BYLAW C-7991-2020**A Bylaw of Rocky View County, in the Province of Alberta, to adopt the Ascension Conceptual Scheme**

SCHEDULE 'A'
FORMING PART OF BYLAW C-7991-2020

A Conceptual Scheme affecting Block 6, Plan 8710757, NE-18-25-2-W5M; Block A, Plan 9212196, SE-19-25-2-W5M; a portion of SE-19-25-2-W5M; and SW-19-25-2-W5M, herein referred to as the Ascension Conceptual Scheme.

Figure 1 - Regional Context

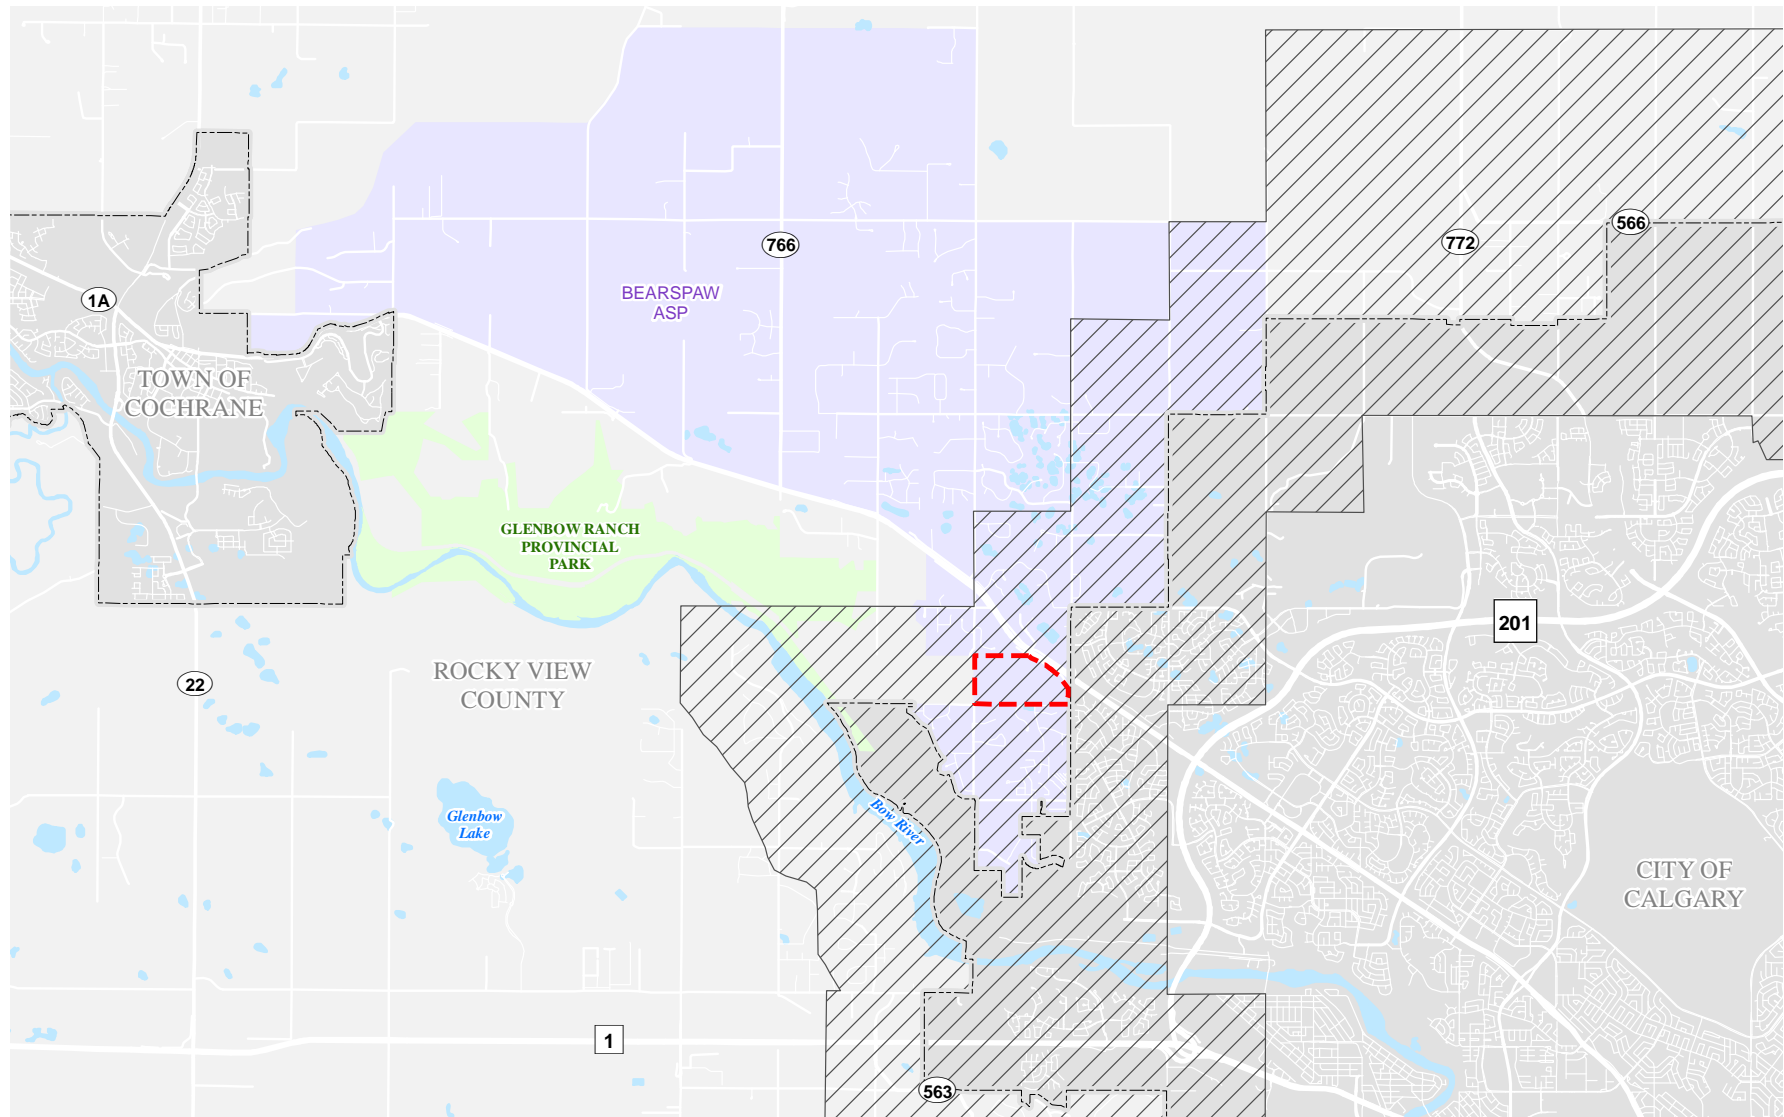
Figure Added

Figure 2 - Regional Residential Context

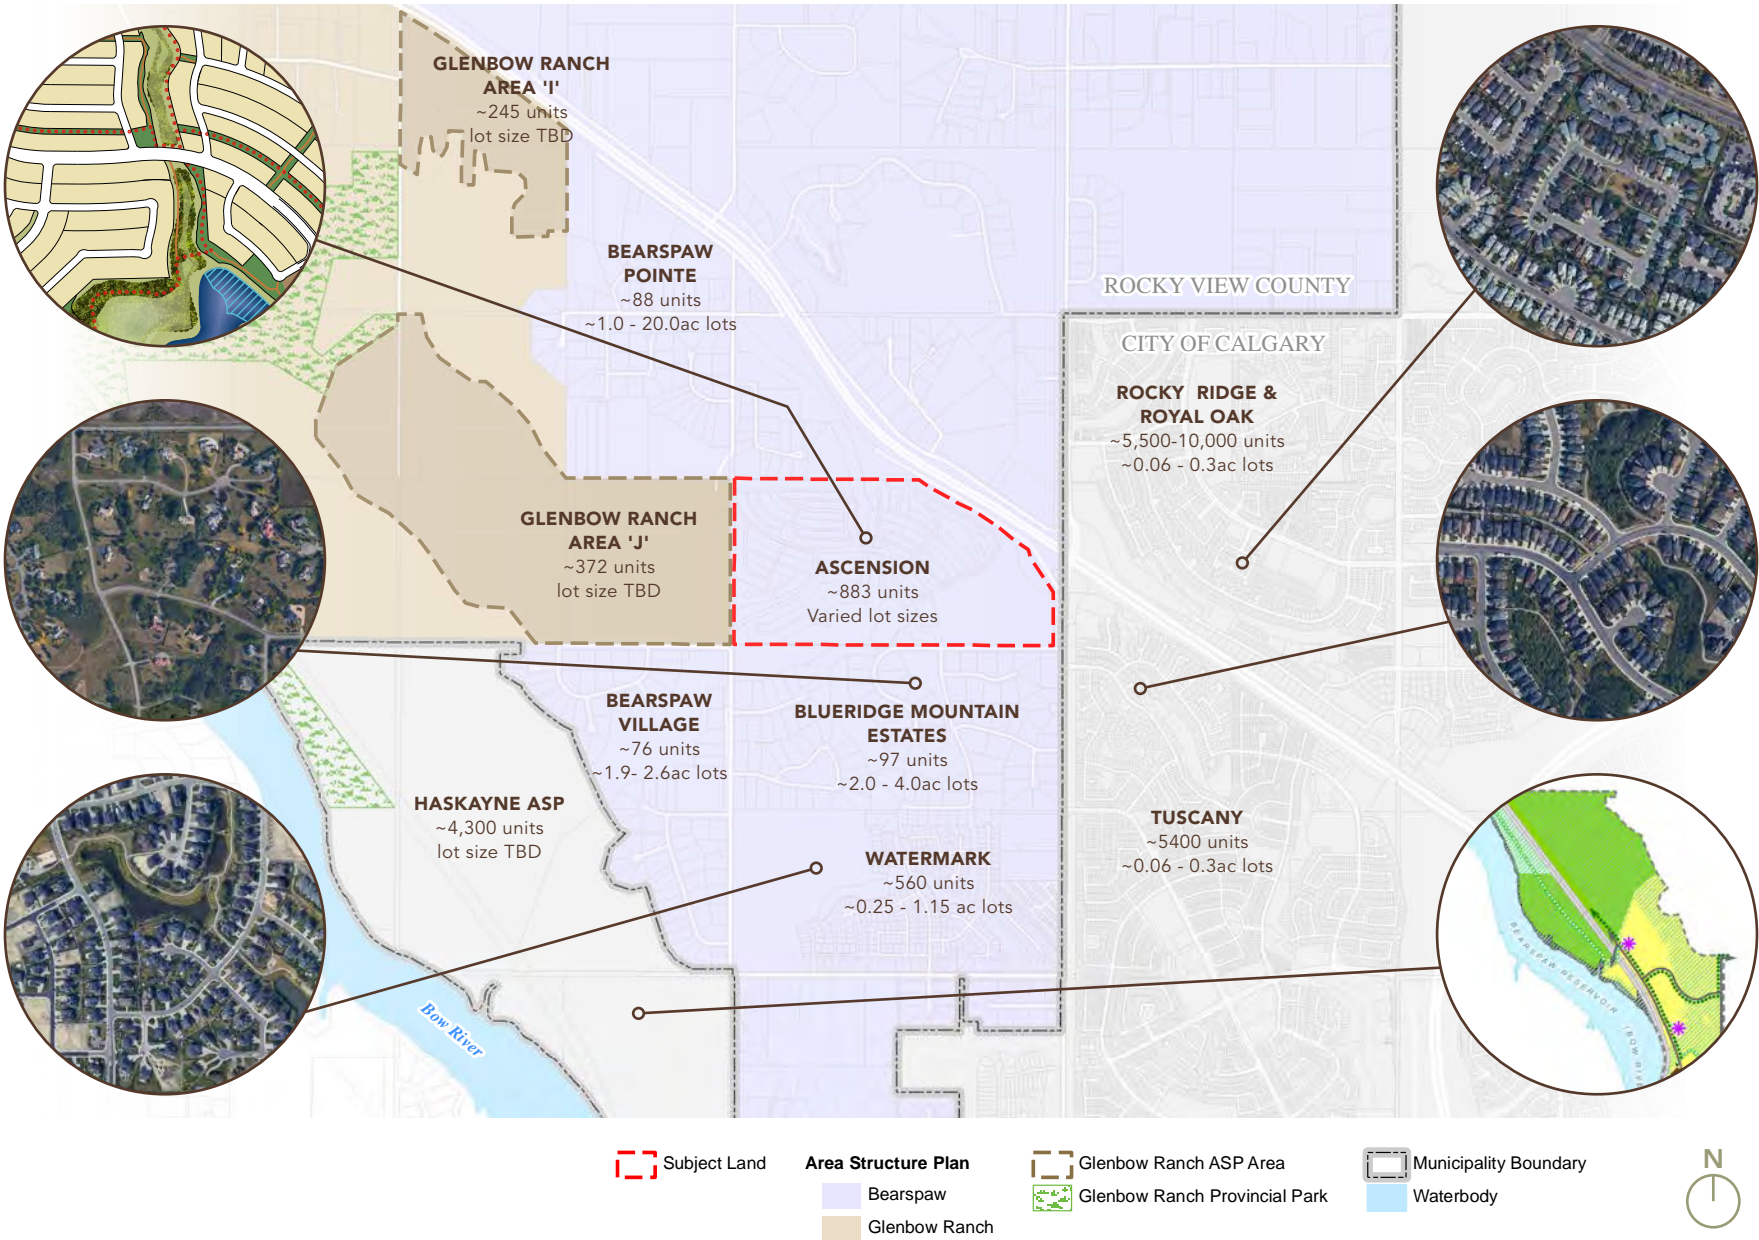
New Figure, significantly updated from former Figure 1

Figure 6 - Location

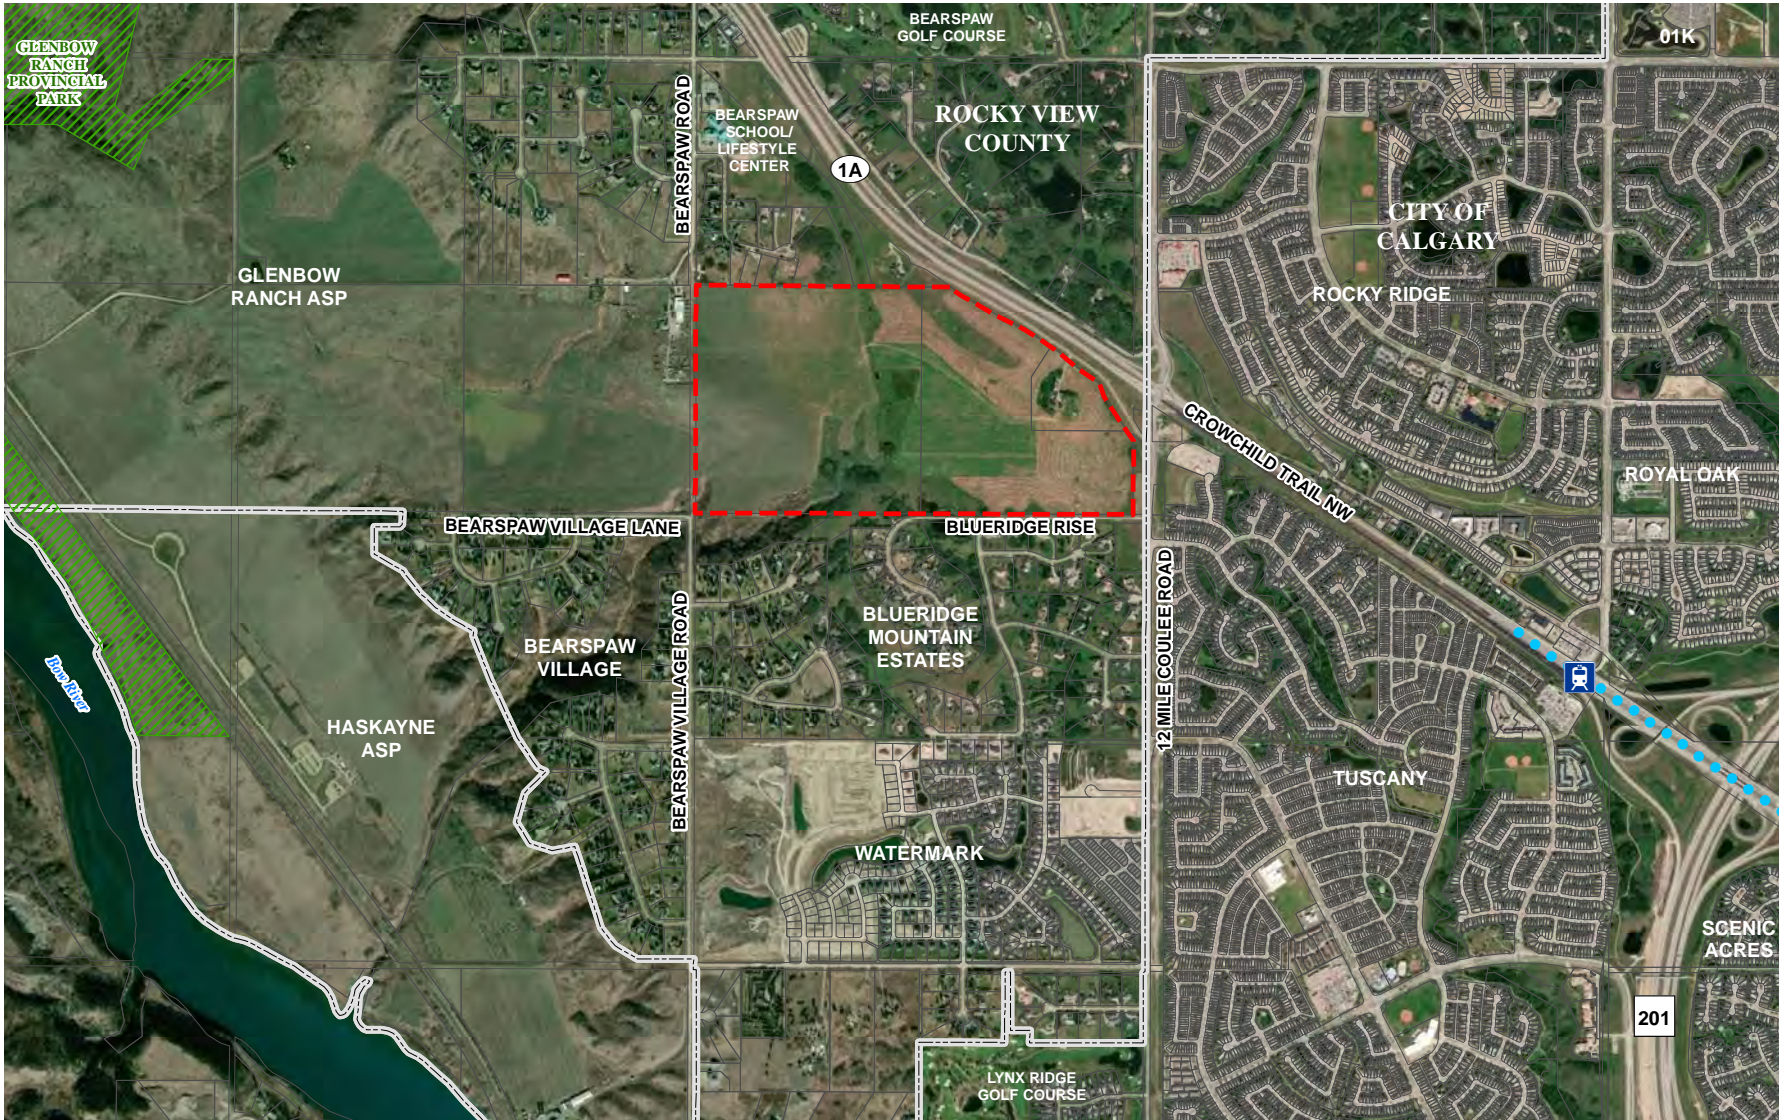
Formerly Figure 2 - Figure was updated

Figure 7 - Titled Ownership Parcels

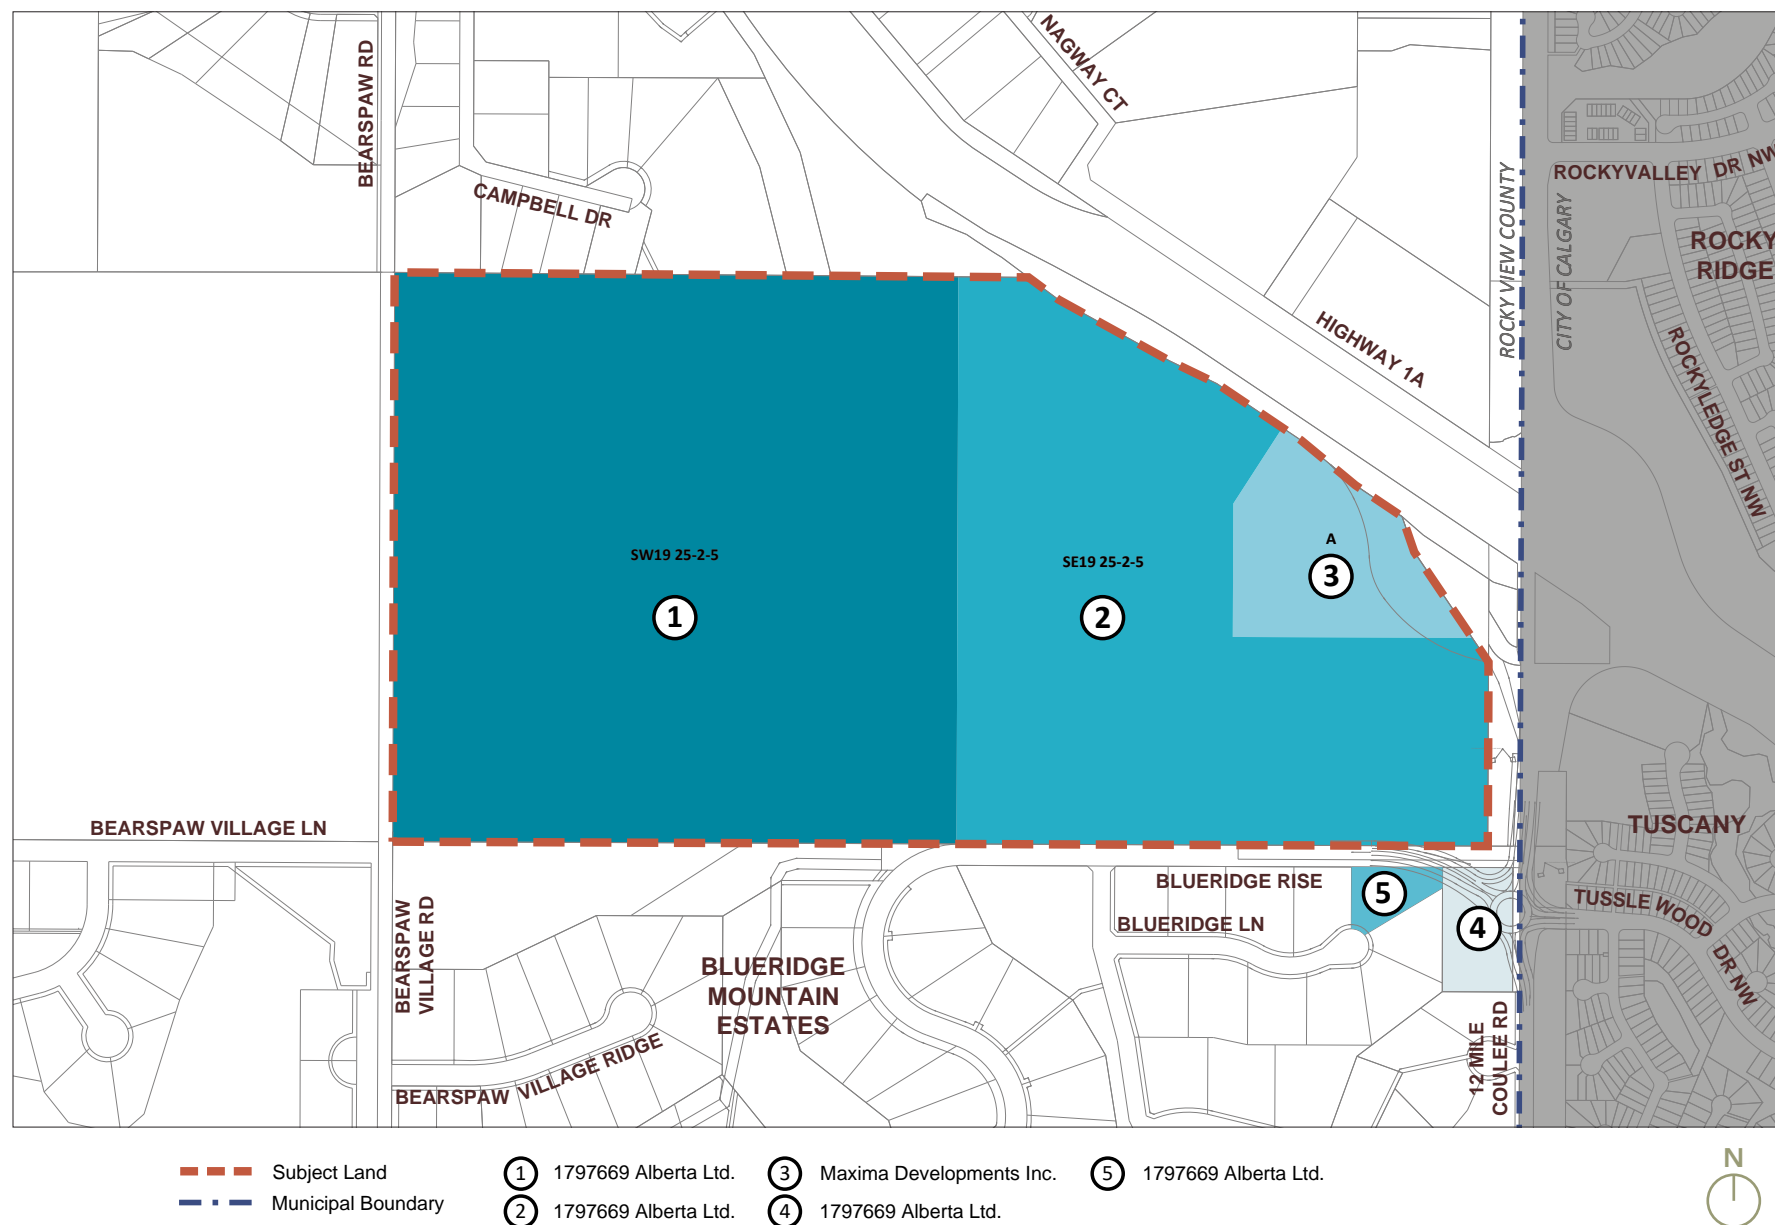
Formerly Figure 3 - Figure was updated

Figure 8 - Existing Site Conditions

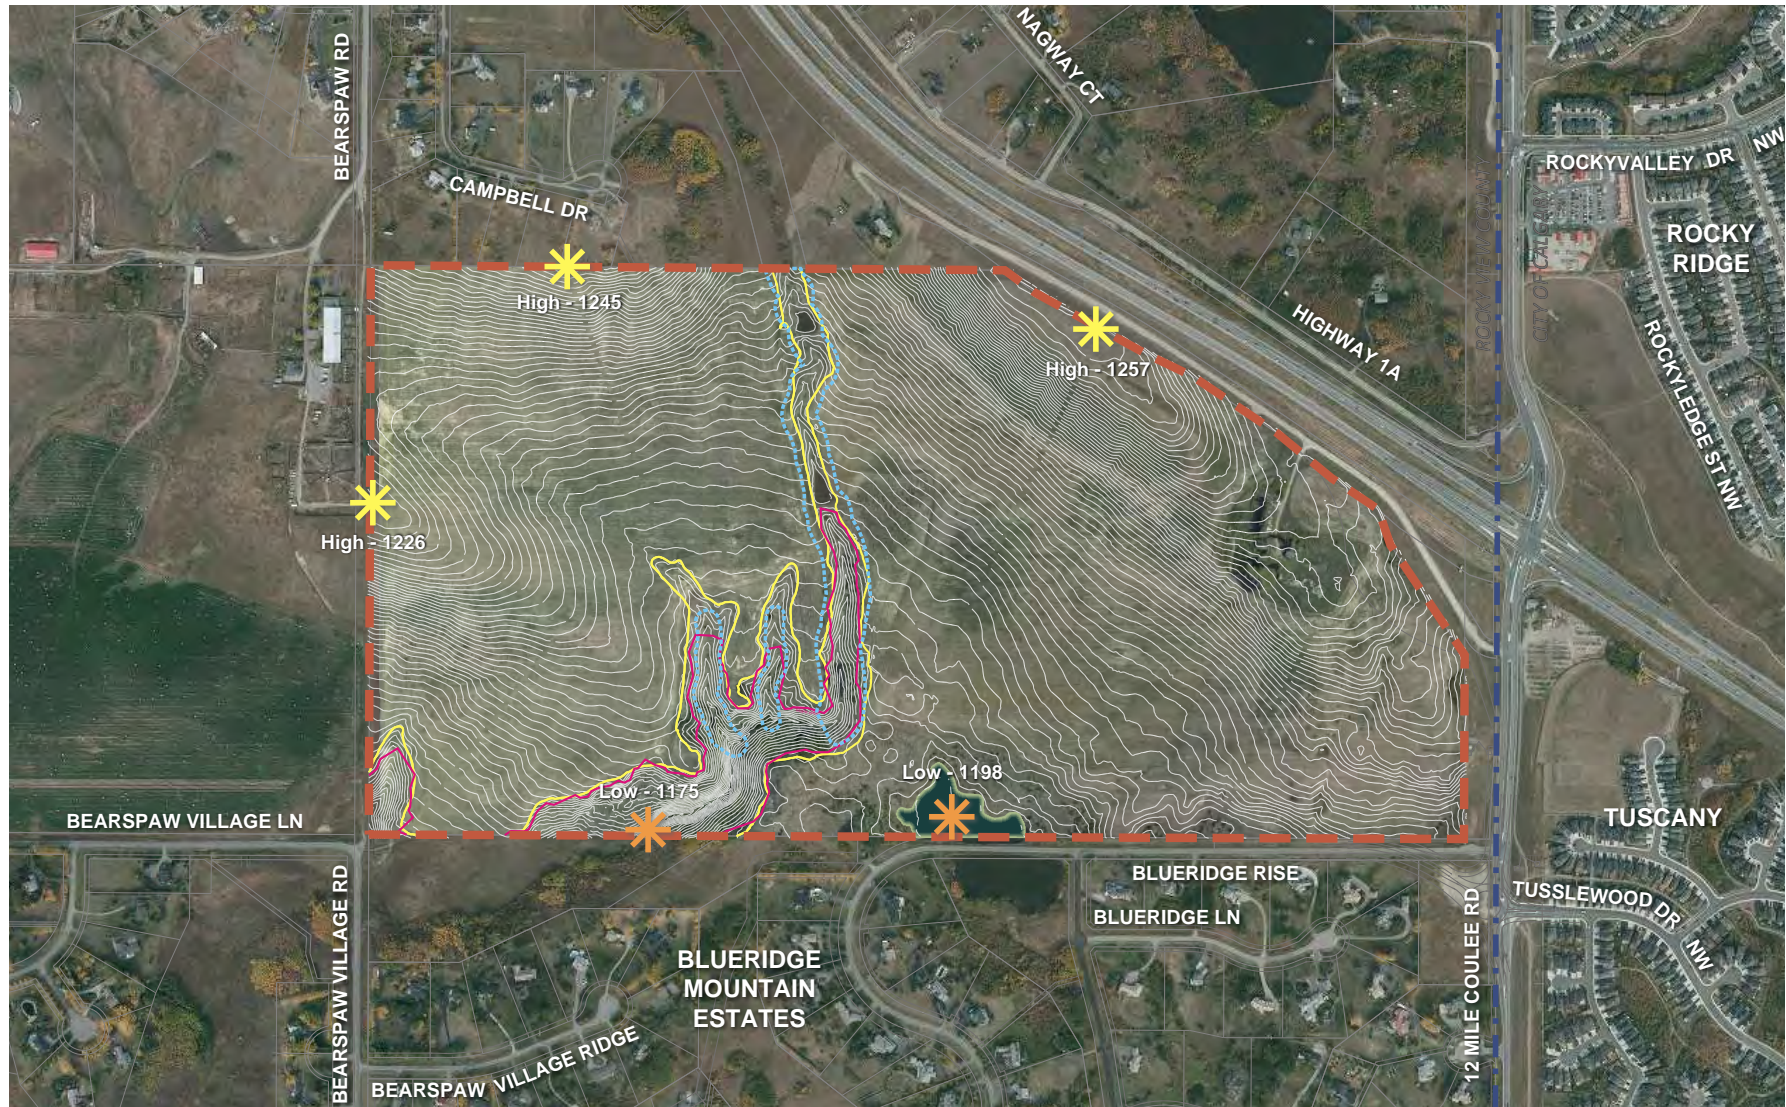
Formerly Figure 4 - Figure was updated

Figure 10 - Market Place Conceptual Site Plan

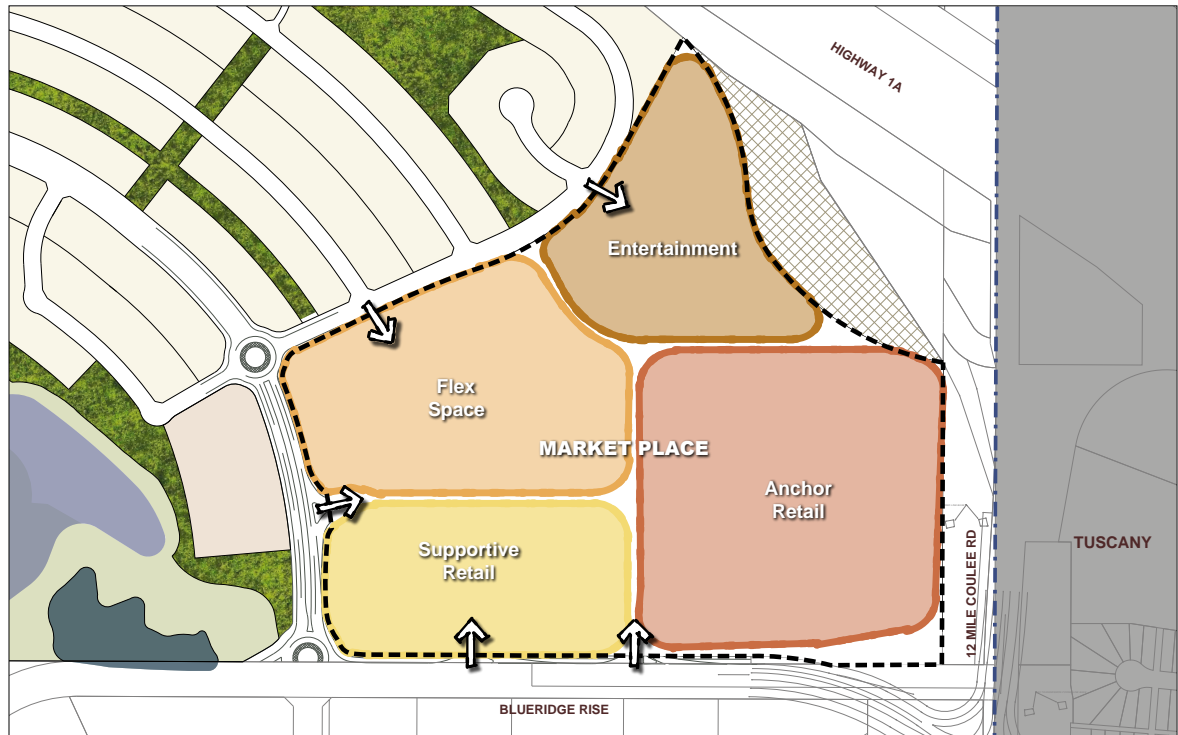
Assigned a Figure number, previously unassigned
